**GENERATOR SET DIESEL ENGINE DRIVEN 4.5 kW (5.6 KVA) 240 V AC,
SINGLE PHASE, 50 Hz (AIR-LOG 4169A)**

MODIFICATION INSTRUCTIONS AND INDEX

MODIFICATION INSTRUCTION No 1

SUBJECT: Removal of existing 1.4 kg fire extinguisher/bracket and fitting a 2 kg dry powder fire extinguisher/bracket.

Fig 1 Cover assembly

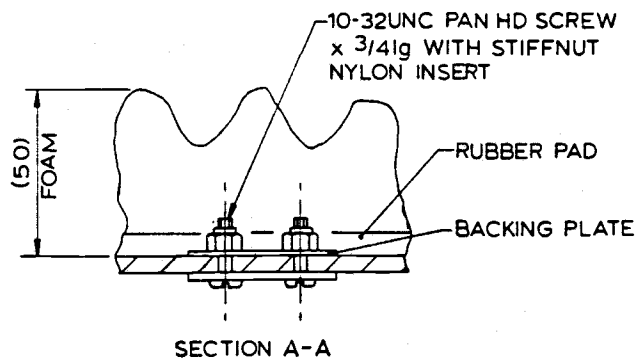
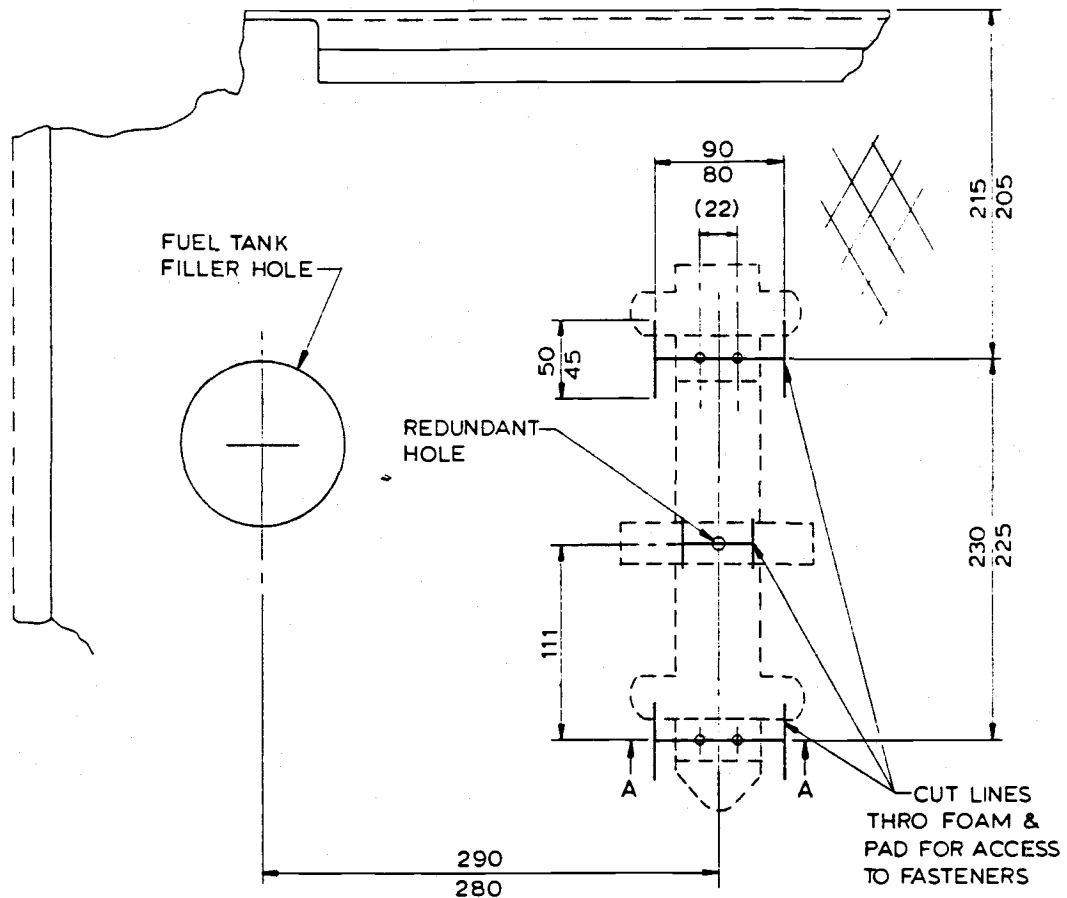
9.1.4 Cut foam lining as shown in Fig 1.

9.2.3 Fit and secure bracket (item 2), backing plates (item 3), screws (item 4) and nuts (item 5) as shown in Fig 1 using existing holes in acoustic cover.

Fig 2 Backing plate

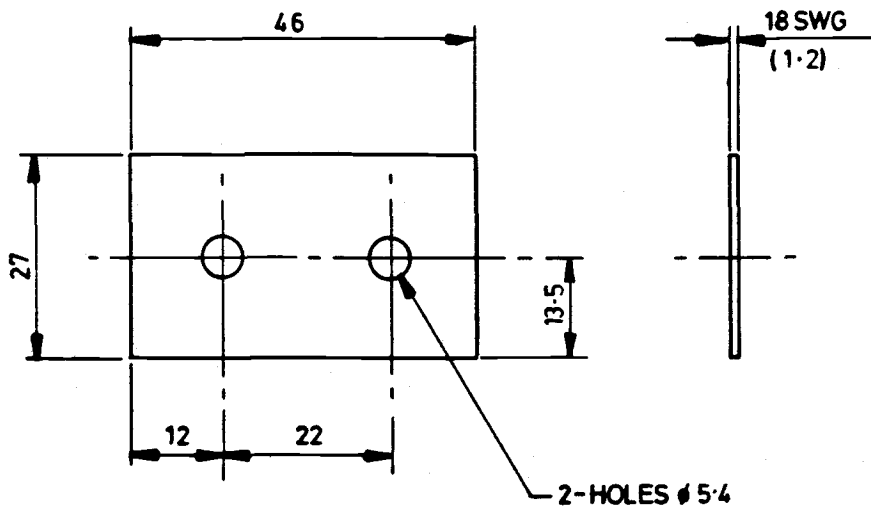
9.2.2 Manufacture backing plates (item 3) as shown in Fig 2.

Fig 1 Assembly of free end connector

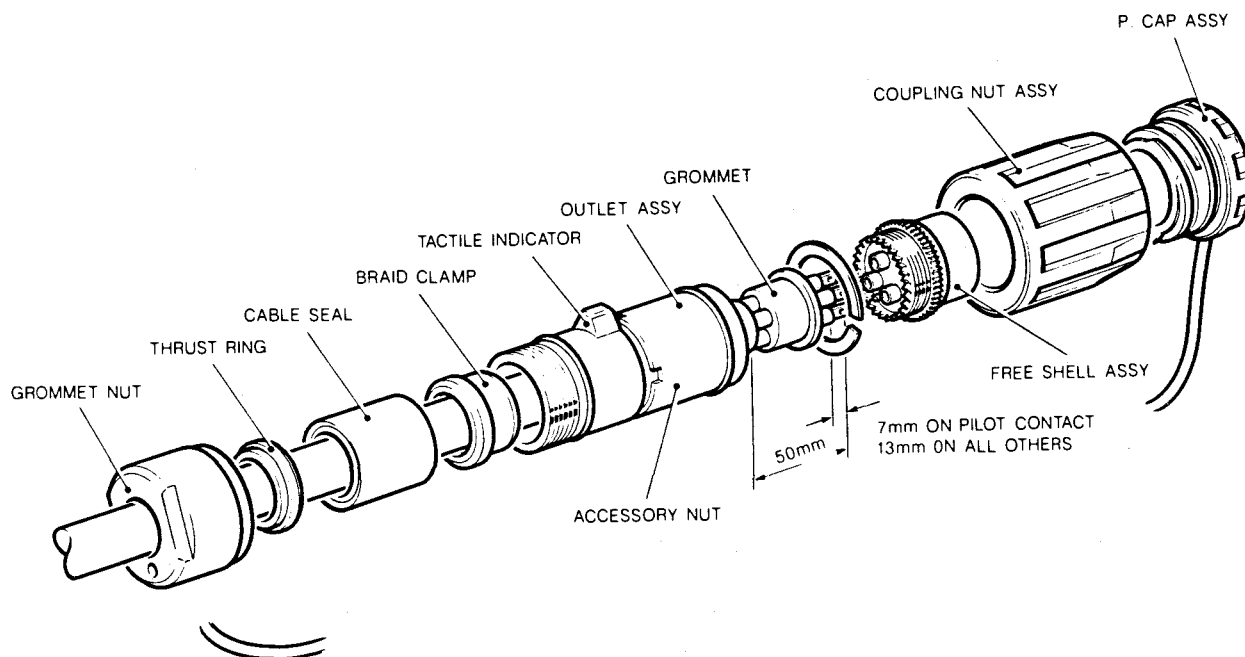
POWER CABLE SPECIFICATION. THE EXISTING POWER CABLES CAN BE USED ONLY IF THEY ARE OF THE CORRECT DIAMETER AND POWER CARRYING CAPABILITY TO FIT THE FREE END CONNECTORS. THE ITEMS DETAILED IN SUB-PARA 8.4 ABOVE ARE KNOWN TO MEET THESE REQUIREMENTS AND ARE THE RECOMMENDED ALTERNATIVES. IF PROBLEMS WITH THE CABLES ARE ENCOUNTERED, CONTACT FIELD EQUIPMENT AND RECOVERY GROUP FOR ADVICE. THE INSTRUCTION DETAILED BELOW APPLY TO ONE CABLE END. ALL ASSEMBLY DETAILS REFER TO FIG 1.

9.1.1 Strip the cable to the dimensions given, and tin the ends of the cable.

9.1.2 Slide the following items onto the cable, ensuring that they fitted in the correct order and orientation:

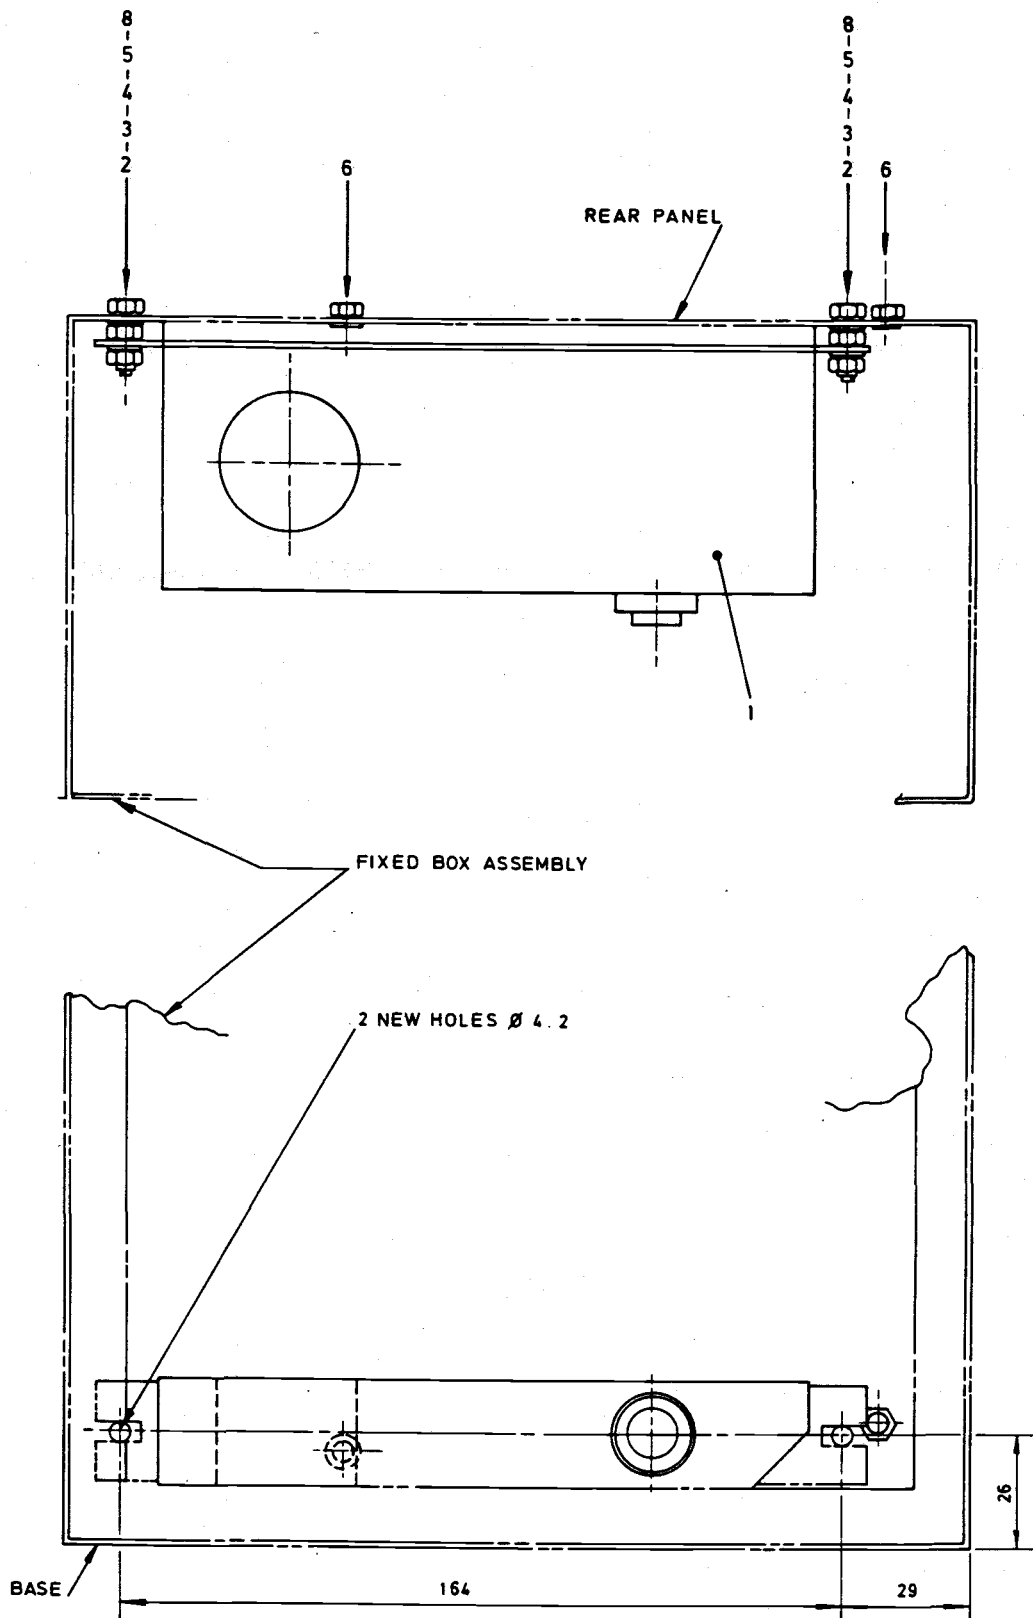
9.10 Referring to Fig 1, mark out and drill two Ø4.2 mm holes in the rear panel of the fixed box.

9.14 Using screw, nuts and washers, (items 2, 3, 4, 5 and 8), refer to Fig 1 and assemble RCD onto the fixed box rear panel. Re-secure wiring loom using cable ties as required.

Fig 1 General arrangement

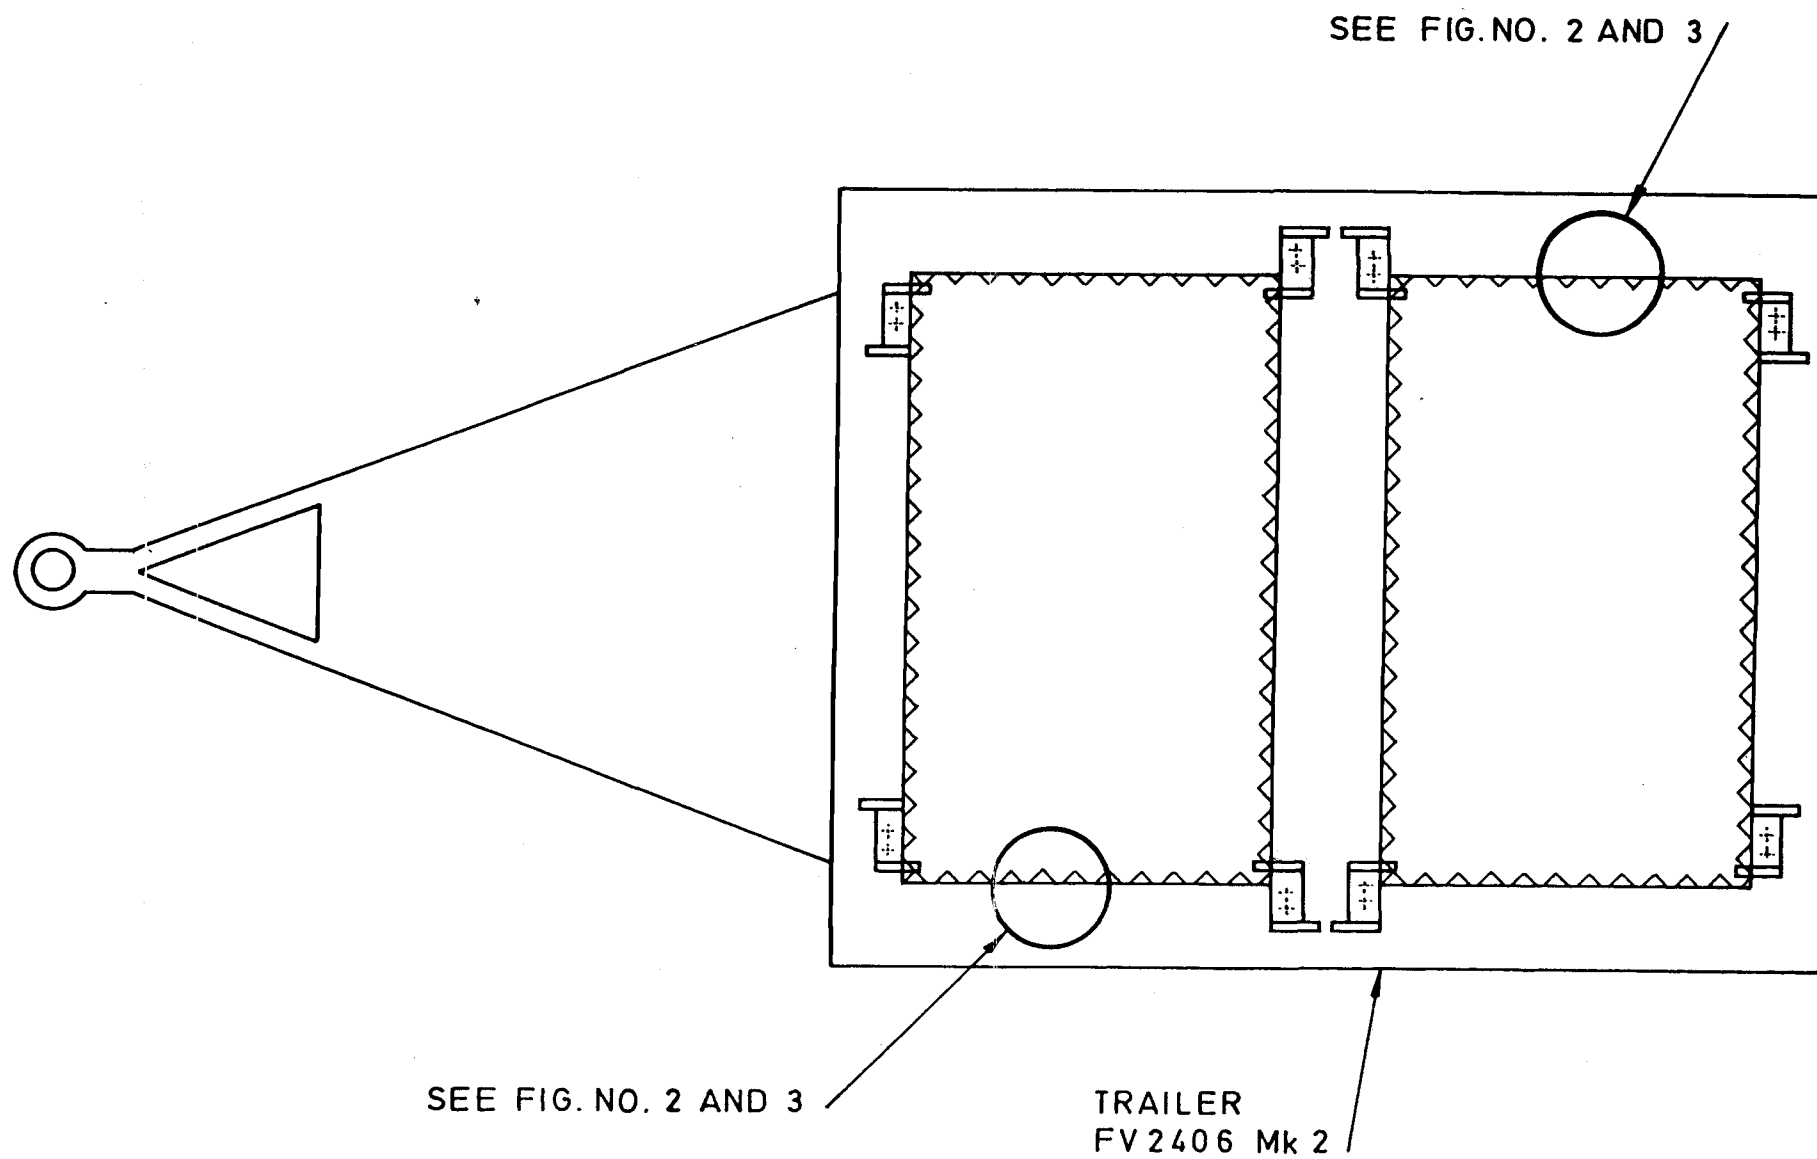
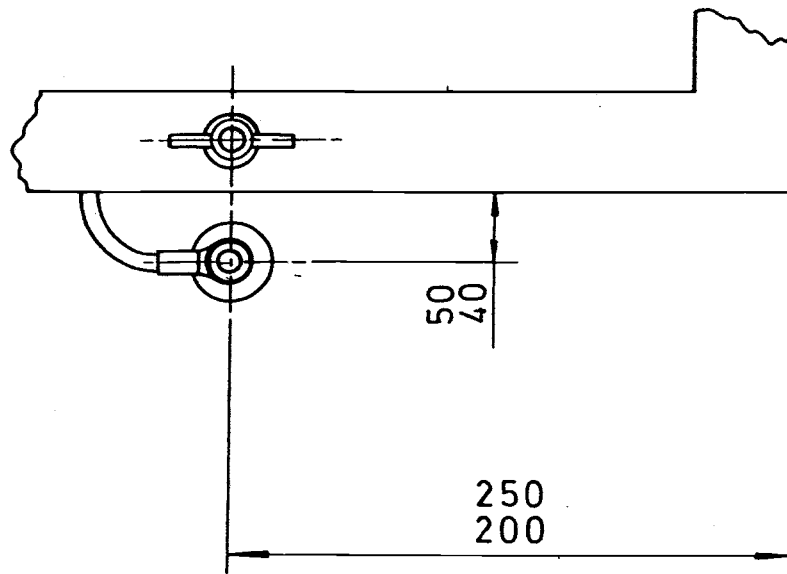
9.3 Remove the paint around the holes, on the underside of the steel floor, to a diameter of approximately 22 mm.

Fig 1 General arrangement

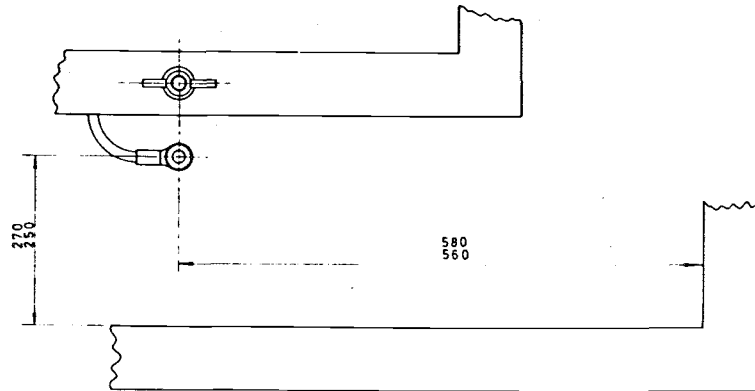
9.3 Remove the paint, to a diameter of approximately 22 mm, around the trailer floor hole on the top side and around the trailer chassis frame on the underside.

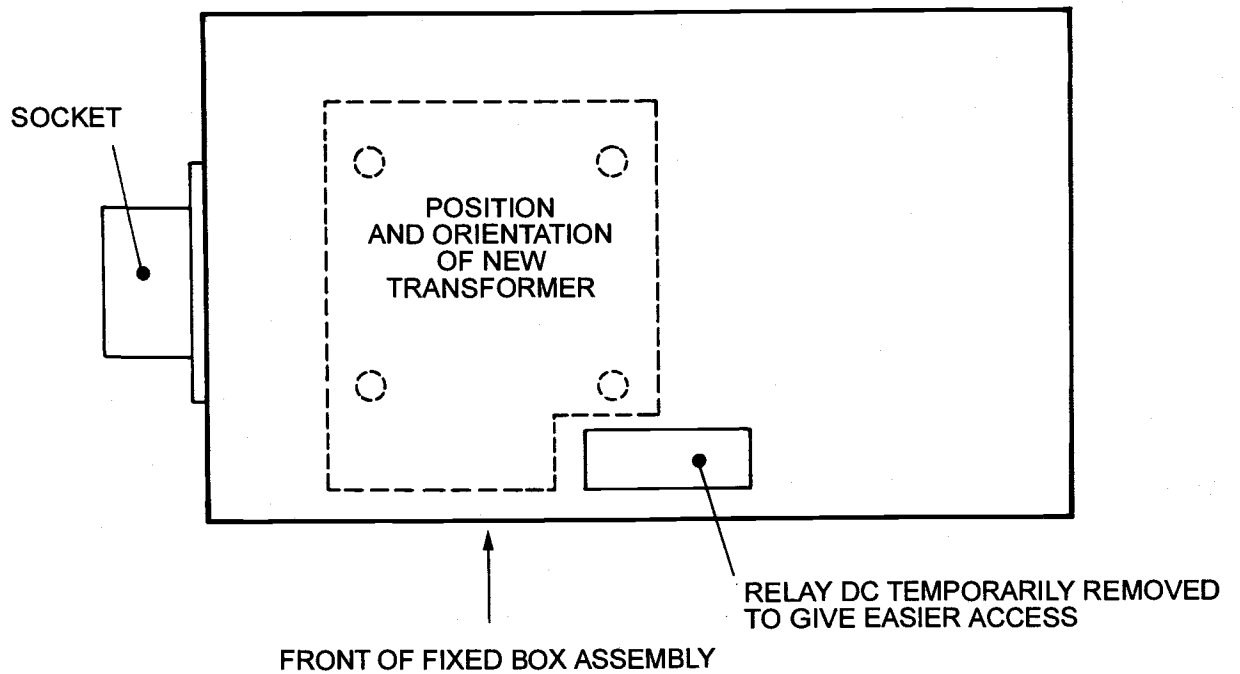
- 9.3 Remove the 16 counter sunk screws securing the front cover of the fixed box assembly to gain access to the existing transformer.
- 9.4 Remove two screws holding relay DC (see Fig 1) and pull it down and out of the way to give easier access to existing transformer.

Fig 1 Resilient mount

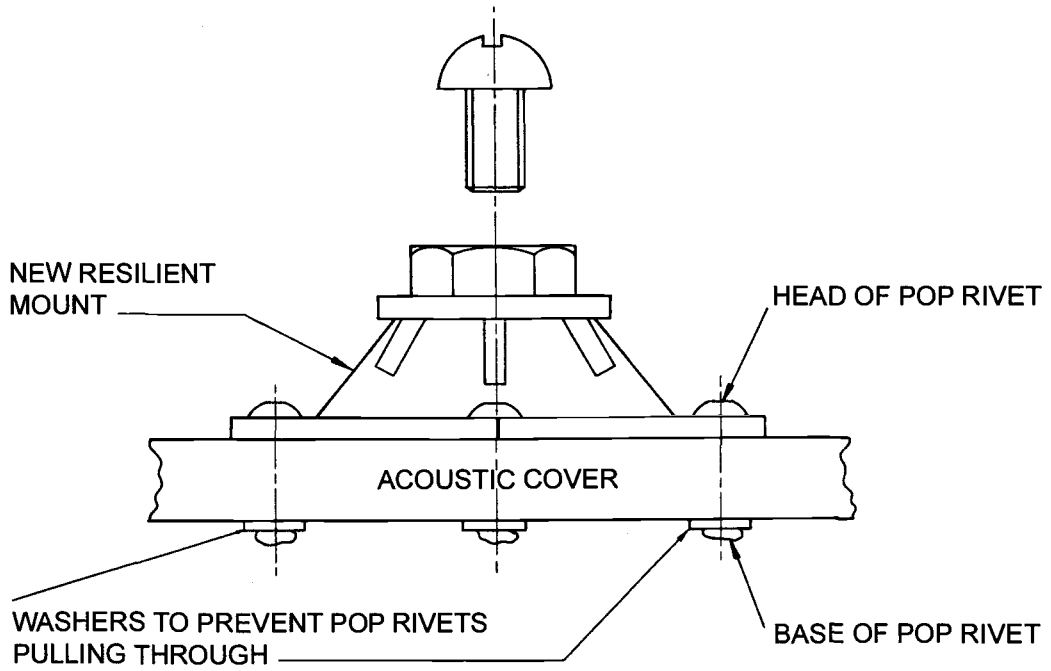
1 The mounts resilient fitted to the generator are not very effective and a replacement has been found that will replace the old style. The new mount resilient is different. On failure of one mount, all four are replaced. This instruction details the fitting of the new mounts resilient upon failure of the existing mounts.

- 9.1 Remove remote box from mounting tray by releasing two toggle clamps.
- 9.2 Undo the seven quick release fasteners that secure acoustic cover to frame. Using a minimum of two persons, remove the acoustic cover.
- 9.3 Unscrew four M4 hex head screws retaining mounting tray to gain access to resilient mounts.
- 9.4 Pull back the acoustic lining on the opposite side to the 'HOT AIR' outlet as required. This allows access to fit washers to the underside of the pop rivets. No fitting of washers or removal of acoustic lining is necessary when pop riveting the mounts on the 'HOT AIR' side as an aluminium under plate is fitted.
- 9.5 Drill through the rivets retaining the existing mounts using a 4 mm drill.
- 9.6 Discard old resilient mounts.
- 9.7 Open up the four holes in the new mounts using 4 mm drill to accommodate the pop rivets supplied.

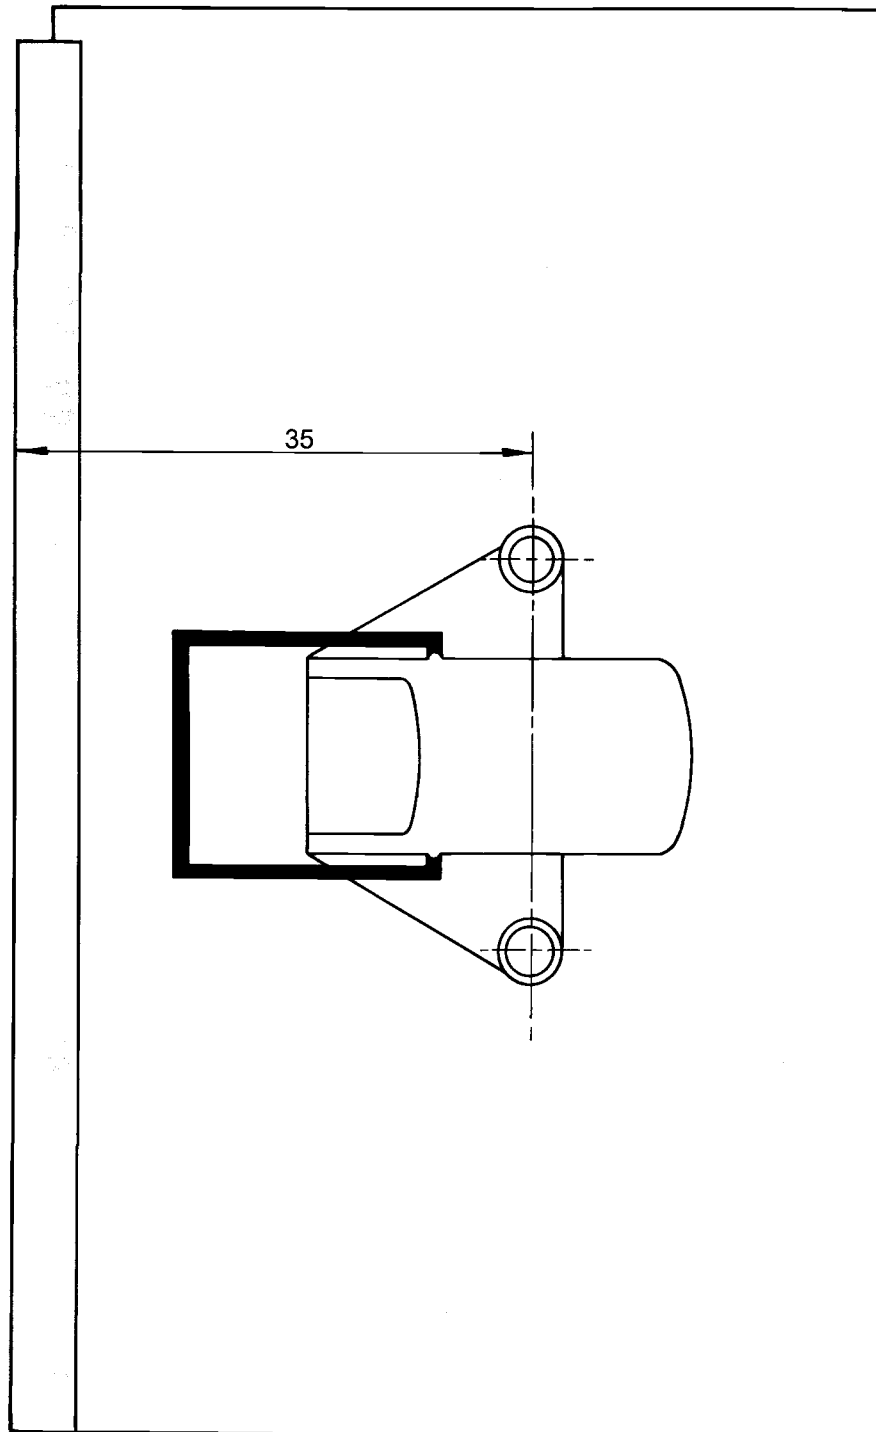
- 9.9 To ascertain the vertical position of the new latch, place it onto the cover so it engages the existing clip, refer to Fig 1 for the correct distance from cover edge to ensure latch locks down firmly. Mark cover using a marker pen.
